CHANCE
MANUFACTURING CO., INC.

Service Information

Ride: YO YO

Subject: MAINTENANCE

SEE REVERSE SIDE FOR DRAWING

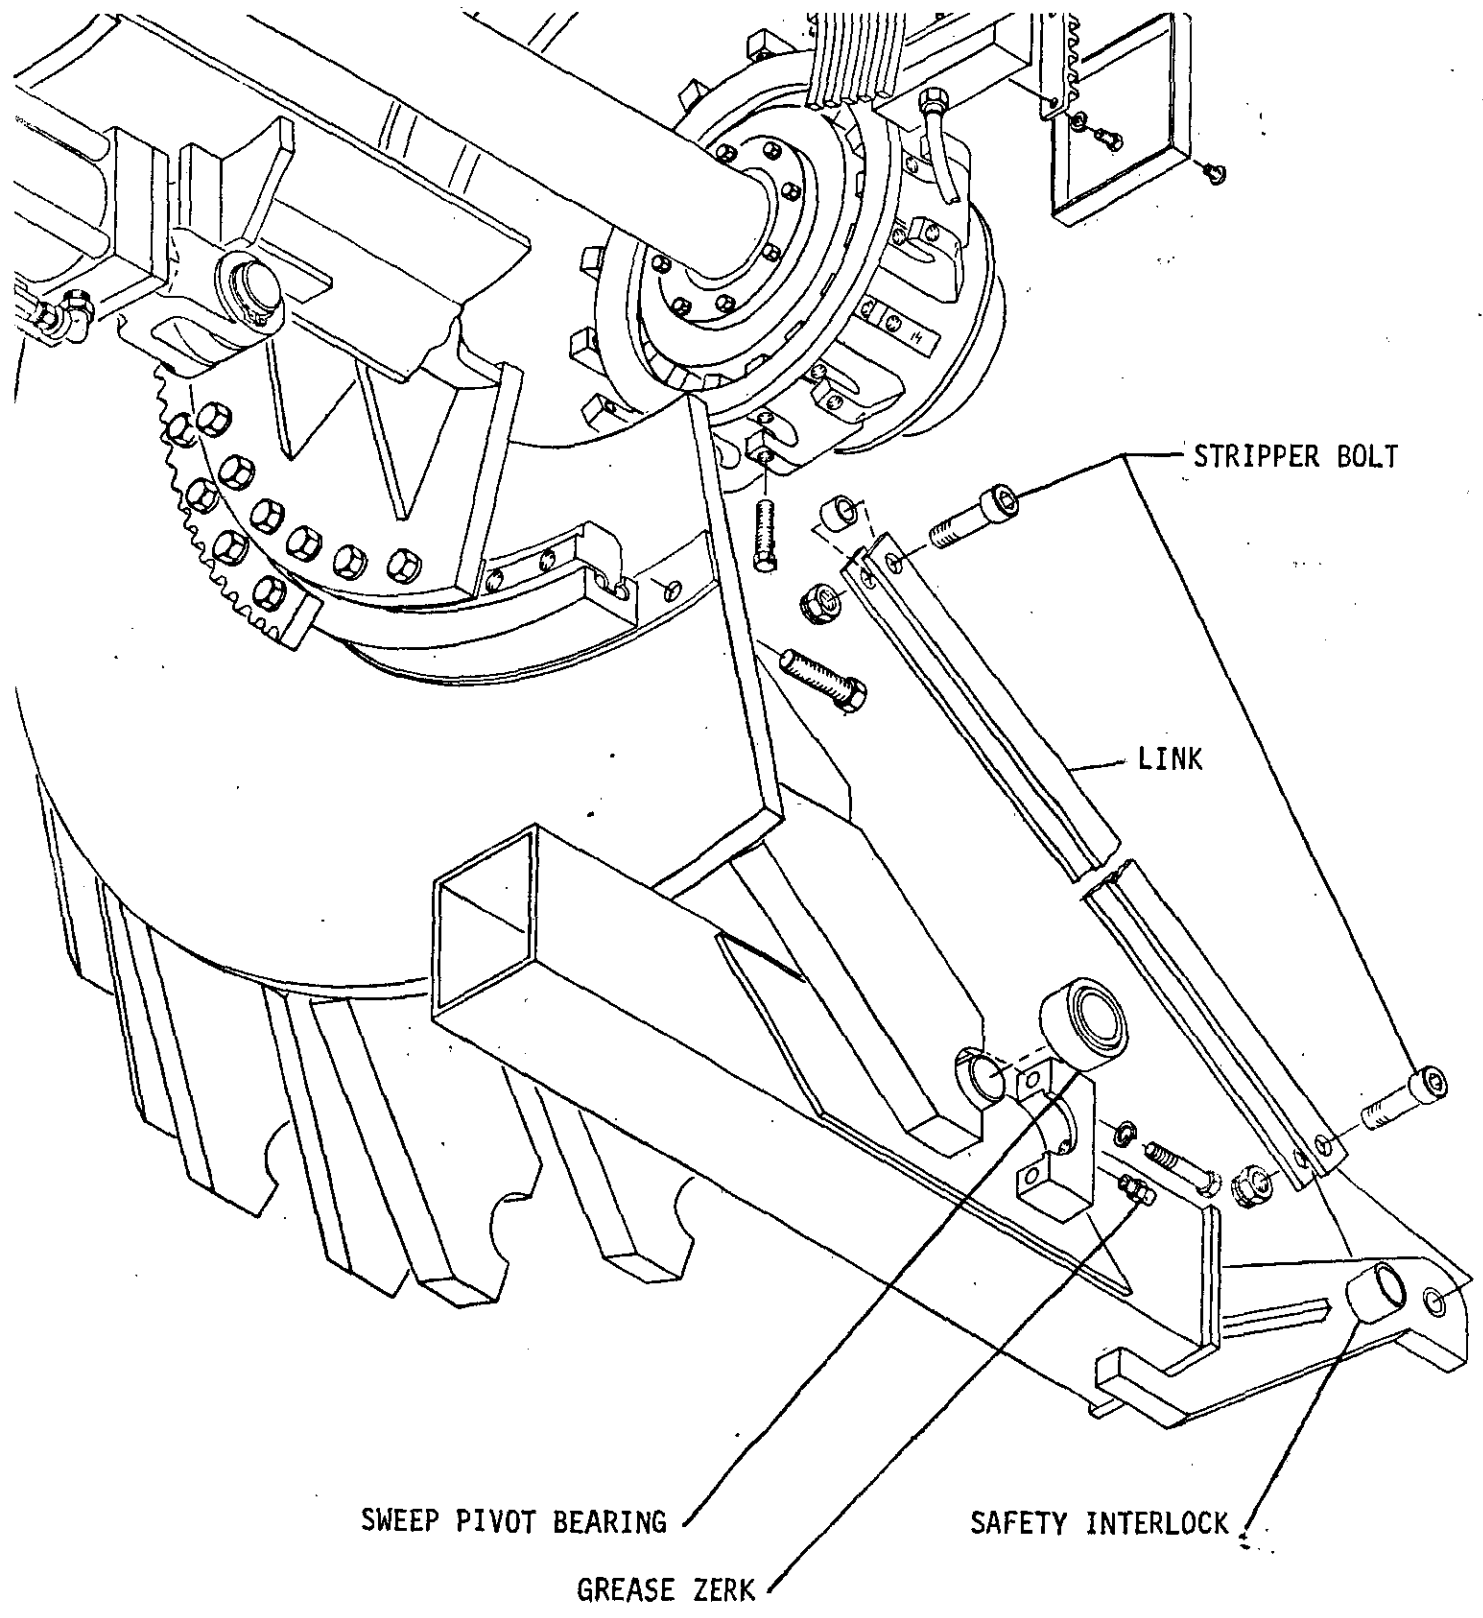
On some rides the safety interlocks have been removed because of interference from bent sweeps. The interlocks are installed at the factory to help insure safe operation and should never be removed or altered.

The links and stripper bolts connecting the hub to the sweeps should only be replaced with factory purchased parts or parts meeting factory specifications.

The sweep pivot bearings should be greased weekly with the sweeps in full up, full down and several intermediate positions to grease the entire bearing. Teflon bearings which require no lubrication are available from the factory.
